# Stage 2 & 3 Site 3 – Australia Towers Sydney Olympic Park

Section 75W - MOD 3  
Environmental Assessment Report

May 2013

FIGURE 2 – APPROVED PODIUM PODS AT LEVEL 1

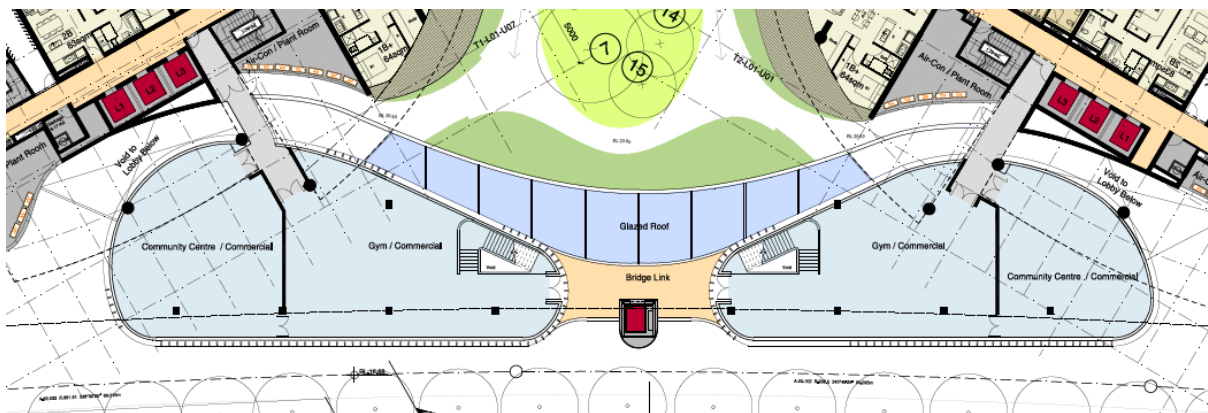
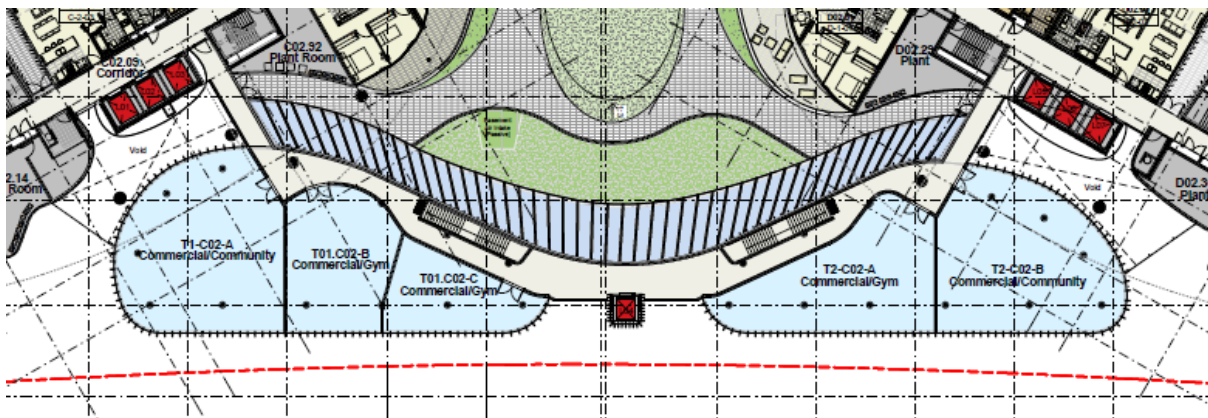
It is proposed to reconfigure the circulation space at Level 1 at provide access from ground level to each of the tenancies at Level 1.

FIGURE 6 – LEVEL 24: APPROVED AND PROPOSED PLAN

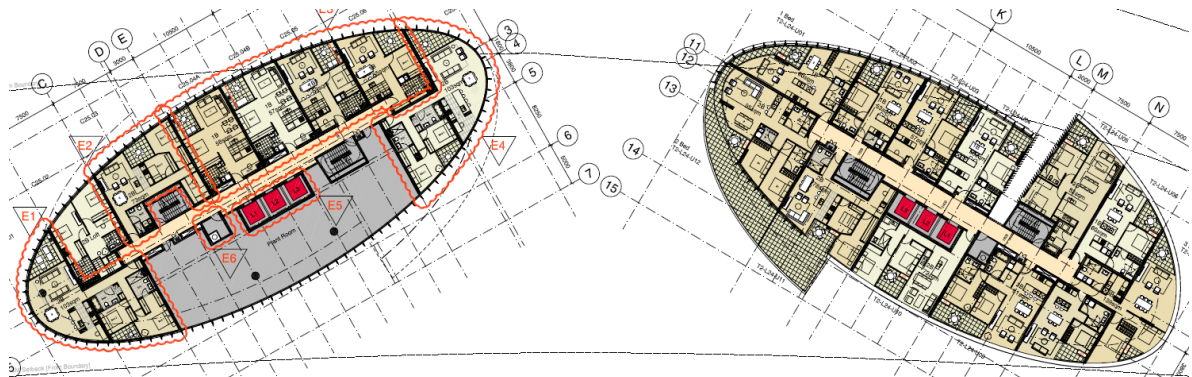
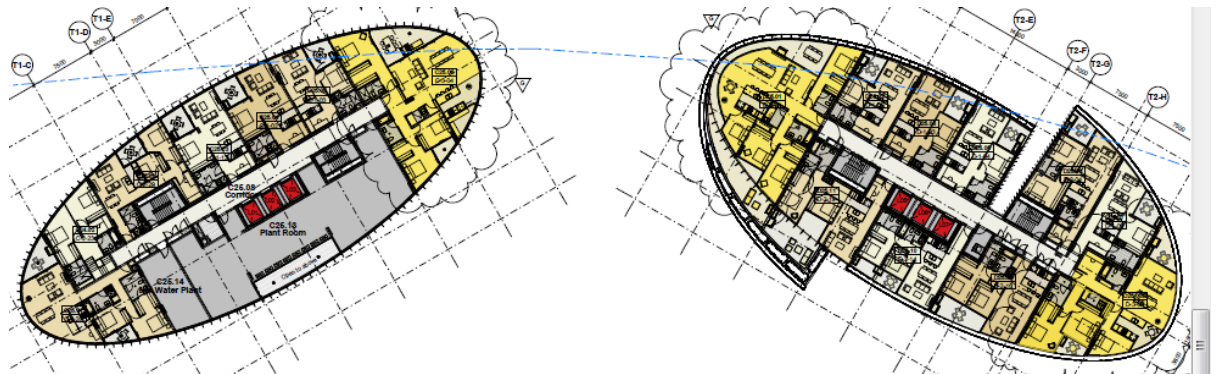
Stage 2 Tower: 1 bed unit and 2 bed unit combined into a 3 bed unit (C25.06).

Stage 3 Tower: 1 bed unit and 2 bed unit combined into a 4 bed unit (D25.01) and convert 3 bed (dual key 1 bed & 2 bed) unit to a standard 3 bed unit (D25.08B).

FIGURE 8 – LEVEL 29: APPROVED AND PROPOSED PLAN

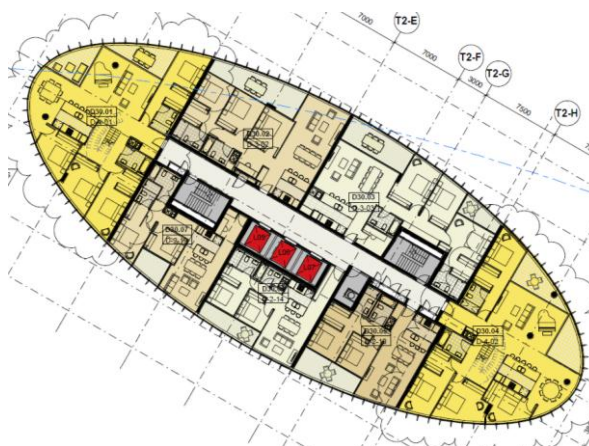
Convert two penthouses from 3 bed to 4 bed units over two levels (Level 29 and 30) and introduce an internal stair to an upper level living room with wintergarden and private open space with pool (D30.01 and D30.04).

FIGURE 9 – LEVEL 30: APPROVED AND PROPOSED PLAN

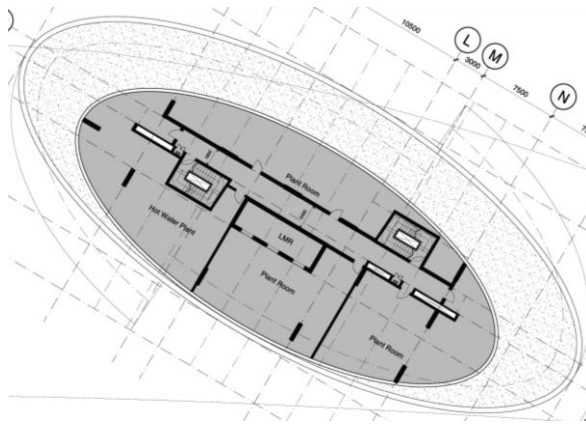
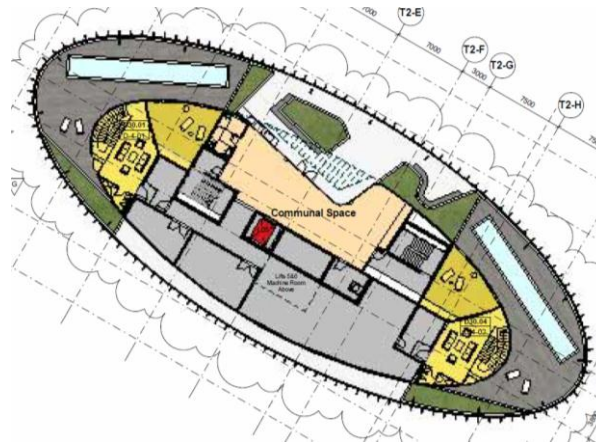
- The approved Level 30 of the Stage 3 tower consists of plant and service space. The proposal seeks the addition of the following on the Level 30 to replace the plant space:
  - Internal and external communal space; and
  - Living room and winter garden space for units D30.01 and D30.04. External private roof terrace space and private swimming pools for units.

FIGURE 10 – LOCATION OF PROPOSED CORE SLAB EXTENSION

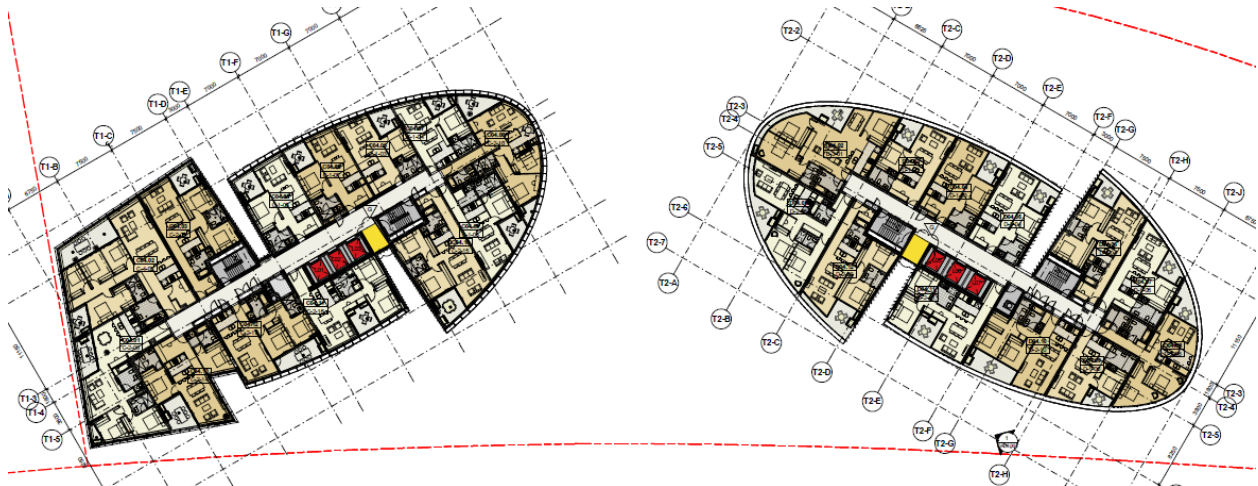
An extension within the vertical 'slot' of both Stage 2 and 3 towers is required for structural reasons. This will provide additional lobby space adjacent to the lift lobby area within both towers.

*"We confirm that the slab that joins the lift core and the stair core in both Towers C & D [Stage 2&3] is required structurally to transmit the horizontal diaphragm forces present in these tall buildings. This slab is required in ensuring that the lateral load resisting system for both towers which is predominantly comprised of the lift and stair shafts which have been joined together to create an efficient box structure is maintained."*

FIGURE 12 – FIXED GLASS CURTAIN WALL ON UPPER LEVEL OF STAGE 3 TOWER

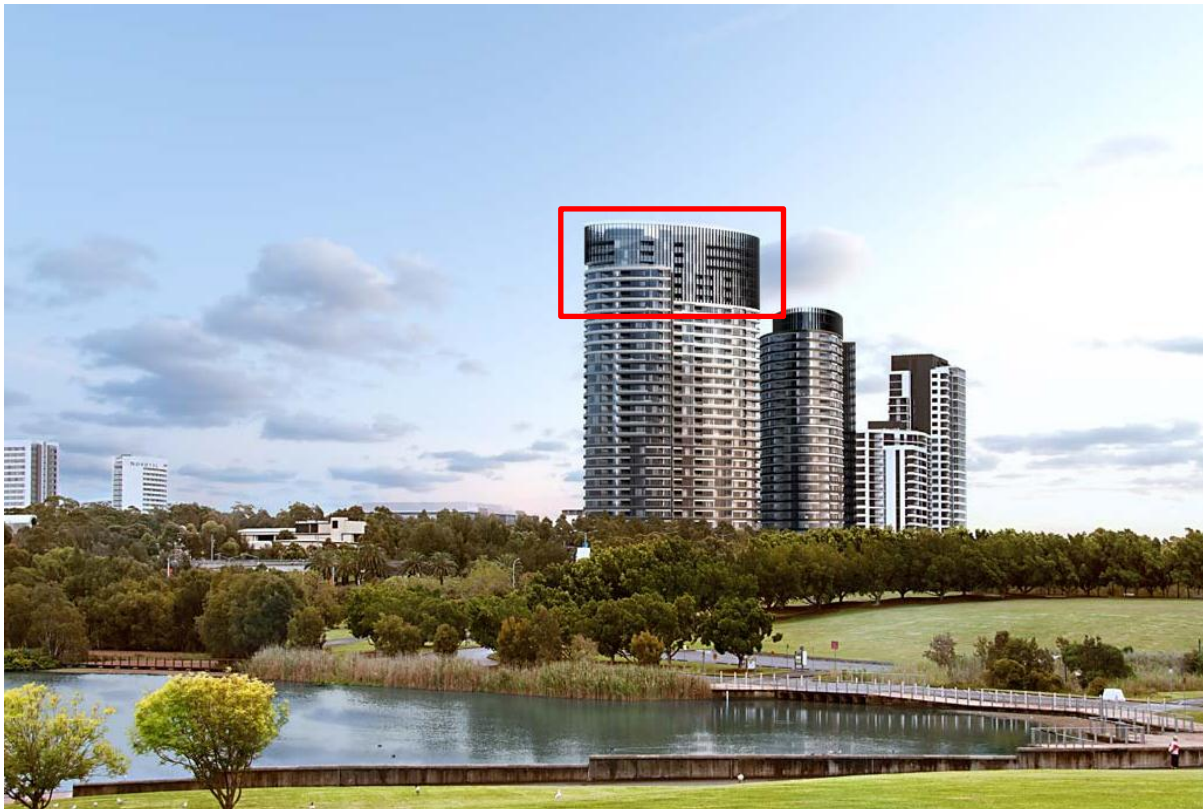
The proposed external modification to the upper level of Stage 3 tower are located behind the fixed glass curtain wall, and will therefore not be readily visible to the surrounds.
